SOLDIER PILE & LAGGING WALL WAR-SR48-6.65

CHOICE ONE ENGINEERING CORP SR-48 AND BUTTERWORTH ROAD LOVELAND, OHIO

REVIEW COMPLETE

PM	_____
BRIDGES	_____
CONSTRUCT	_____
DRAINAGE	_____
ENVIRON	_____
GEOTECH	Casey Carriere, P.E. 3/13/2026
ITS	_____
MOT	_____
PAVEMENT	_____
ROADWAY	_____
R/W	_____
SURVEY	_____
TRAFFIC	_____
UTILITIES	_____
OTHER	_____
OTHER	_____

1
9
SOLDIER PILE WALL UNDERDRAIN DETAIL
NOT TO SCALE

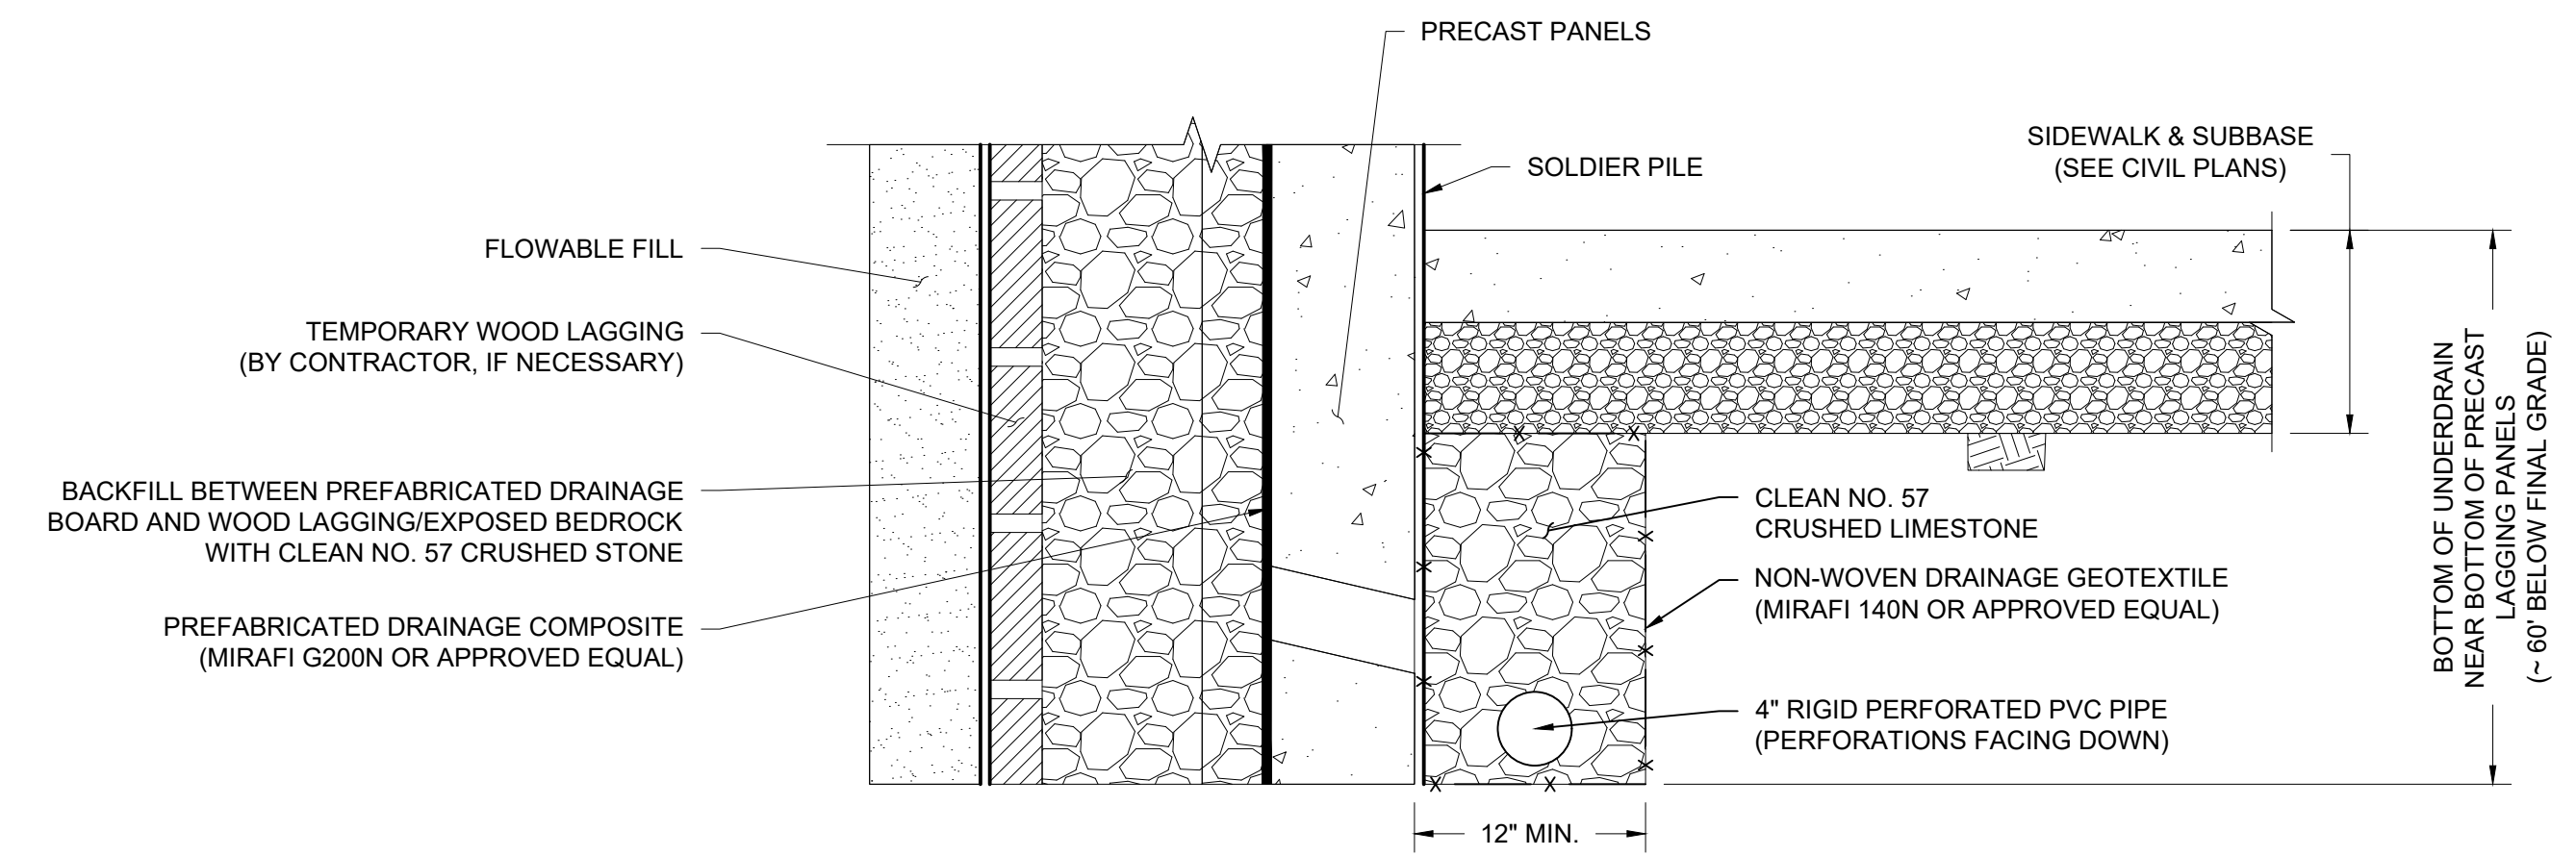
remove
